Access Compliance Report

Public Rights-of-Way

Intersection ID: 19935	Main Street: MORRISON_BV	Cross Street: ADAIR_CT	Location: SE
ADA ID: E3F0799A7E47	Ramp Type: Perp	Initial Pass/Fail: Fail	Overall Compliance: No
Severity Score: 13.75			
Codes/Mitigation Info/Possible Solution		Field Measurements/Component Compliance

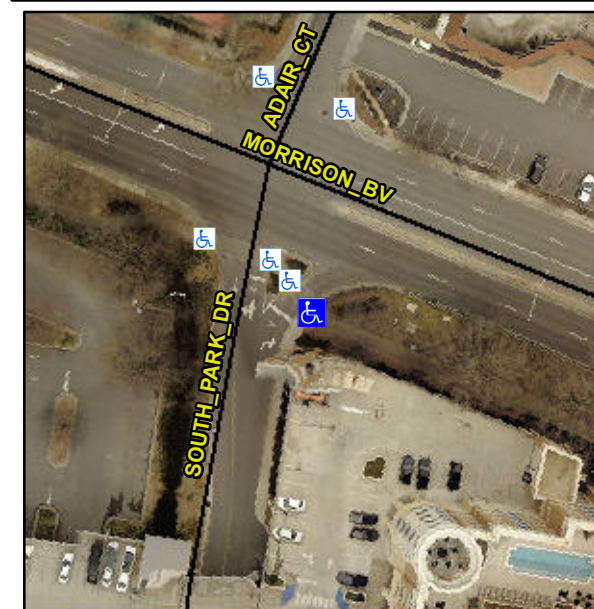
R304.2.2, R304.5.3

Compliance	Description	Data	Compliance	Description	Data
N/A	Ramp Length (in)	48.0	No	Ramp Slope (%)	9.9
Yes	Ramp Width (in)	48.0	No	Ramp XSlope (%)	3.2
N/A	Flare Type LT	N/A	N/A	Flare Type RT	N/A
N/A	Flare Slope LT (%)	N/A	N/A	Flare Slope RT (%)	N/A
N/A	Flare Traversable LT?	N/A	N/A	Flare Traversable RT?	N/A
N/A	Landing Length (in)	N/A	N/A	DWS Provided?	N/A
N/A	Landing Width (in)	N/A	N/A	DWS Contrast?	N/A
N/A	Landing Slope (%)	N/A	N/A	DWS Length (in)	N/A
N/A	Landing X Slope (%)	N/A	N/A	DWS Full Width?	N/A
N/A	Landing Curb? (Y/N)	N/A	N/A	DWS Offset (in)	N/A
N/A	Shared Landing?	N/A			
N/A	Gutter Ponding?	N/A	N/A	Gutter Slope (%)	N/A
N/A	Gutter Lip Ht (in)	N/A	N/A	Gutter X Slope (%)	N/A
N/A	Painted X Walk1?	Yes	N/A	Painted X Walk2?	N/A
	X Walk 1 Direction	To NW		X Walk 2 Direction	N/A
N/A	X Walk 1 Width (in)	96.0	N/A	X Walk 2 Width (in)	N/A
	X Walk 1 Slope (%)	4.4		X Walk 2 Slope (%)	N/A
	X Walk 1 X Slope (%)	0.0		X Walk 2 X Slope (%)	N/A

Remove & Replace Entire Ramp.
